TO: Mercedes-Benz Dealer Principals, General Managers, Sales Managers, Service Managers, Parts Managers	FROM: Gregory Gunther, Department Manager, Vehicle Compliance and Analysis, Engineering Services
RE: Recall Campaign Launch Notification Check Vehicle Body Sealing for Water Intrusion MY20 247 (GLB-Class)	DATE: July 25, 2020

Recall Campaign Launch Notification			July 25, 2020
Campaign No. :	NHTSA ID	Campaign Desc. :	Check Vehicle Body Sealing for Water Intrusion
2020070009	20V246	20P6290301	
<p>This is to notify you of the Recall Campaign Launch to check vehicle body sealing for water intrusion in 26 Model Year (“MY”) 2020 GLB-Class (247 platform) vehicles. The recall campaign will be visible on the www.safercar.gov website and may generate questions from customers. Affected VINs will be flagged in VMI as “OPEN” on July 25, 2020.</p>			
Background			
Issue	<p>Mercedes-Benz AG (“MBAG”), the manufacturer of Mercedes-Benz vehicles, has determined that on certain Model Year (“MY”) 2020 GLB-Class vehicles (247 platform), the vehicle body might not be sealed in the area of the front wheel wells according to current production specifications. Under certain conditions, it is possible fo

Figure 2

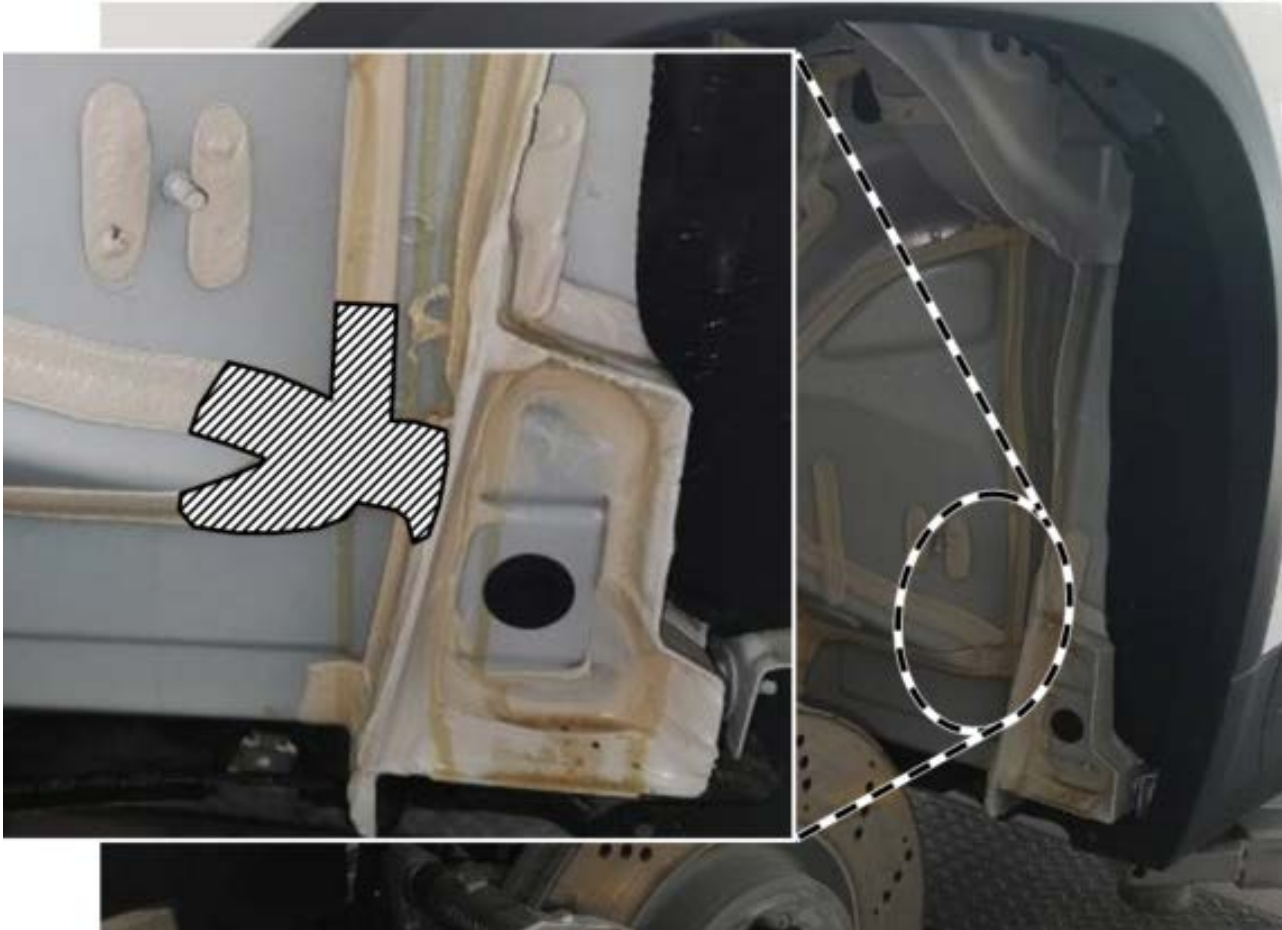
1. Remove rear section of right and left front fender liners.
i For basic data, see **AR88.10-P-1301MFA**.
2. Clean/prime seam seal on right and left of firewall (marked area) and rework with transparent seam seal (**Figure 2**).
